CITY OF PORTLAND BUILDING PERMI

PERMIT ID: 2012-65661

has permission to 1. interior bath renovation 2. enclose porch to create mud room (5.25' x 6.5') 3. Porch additon (6' x 18' 4 3/8") to garage/studio

City of Portland, Maine - Building or Use Permit					Permit No:	Date Applied For:	CBL:	
389	389 Congress Street, 04101 Tel: (207) 874-8703, Fax: (207) 874			4-8716	2012-65661	12/20/2012	090 P008001	
Location of Construction: Owner Name:			0	Wher Address:	Phone:			
224 PLEASANT AVE PI WILLIAMS TIMOTHY A			200 S MAYA PAL	M DR	(561) 394-7799			
Business Name:			Contractor Name: Co		Contractor Address:		Phone	
			Kiely, John 5		591 Island Ave. Pea	aks Island	(207) 766-2026	
Less	ee/Buyer's Nam	ie	Phone:	P	Permit Type:			
					Additions - Dwellin	ngs		
Pro	posed Use:			Proposed	Project Description:			
Sir	gle Family					2. enclose porch to ton (6' x 18' 4 3/8")		
D	ept: Zoning	Status: A	Approved w/Conditions Re	viewer:	Ann Machado	Approval Da	te: 01/14/2013	
N	ote: Using se	ection 14-427 to encl	ose part of existing covered porch	h. The to	tal area of the walls	s is 112 sf; the	Ok to Issue:	
	square f	ootage of the widows	s and door is 60 sf which is 53.6%	6 of area	that is glass.

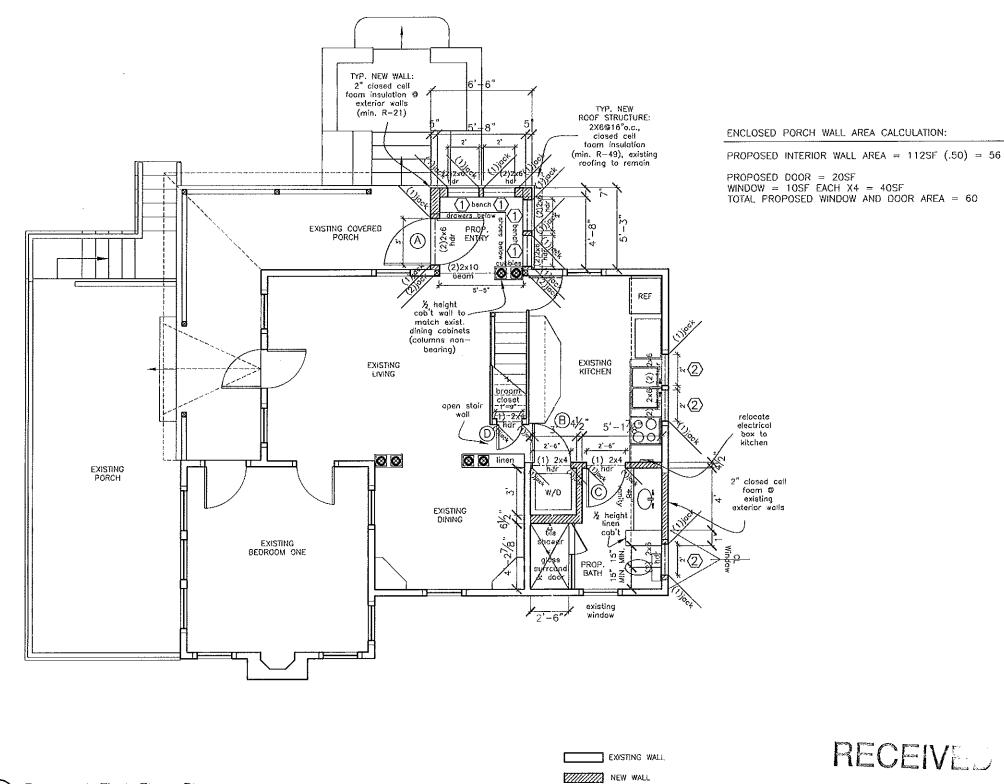
Can you clarify the studio use?

What are the floor joist sizes/ spacing for the proposed entry?

Is the roof to the proposed entry existing?

The studio will be an art studio. It is also a garage in the winter months.

The floor joists for the covered porch are 2x6 at 16"o.c.

The roof to the proposed mud room/entry on the main house is existing.

Proposed First

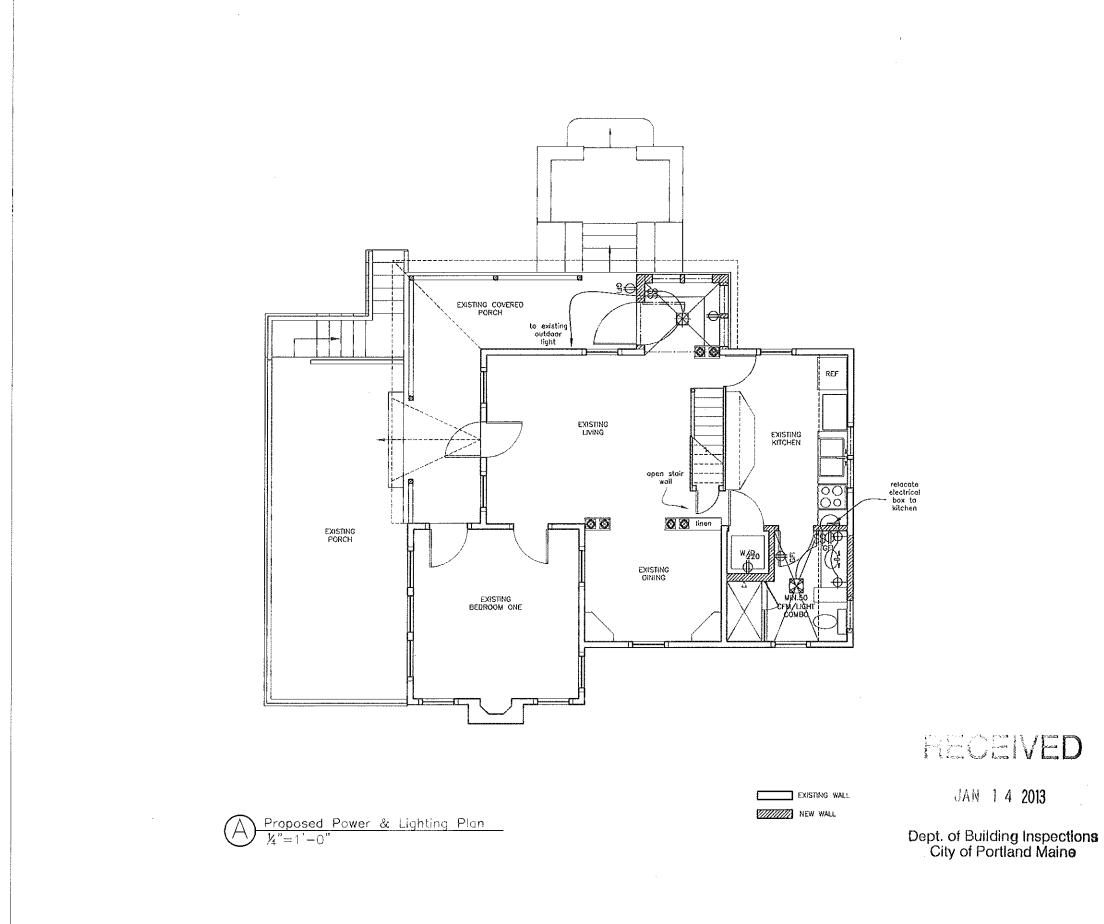
5)) Note: Plans indicate "4x 6 inch Beam", the Girder must comply with Section R502.5 Allowable girder spans. The allowable spans of girders fabricated of dimension lumber shall not exceed the values set forth in Tables R502.5(1) and R502.5(2), or submit specification from the lumbar yard.
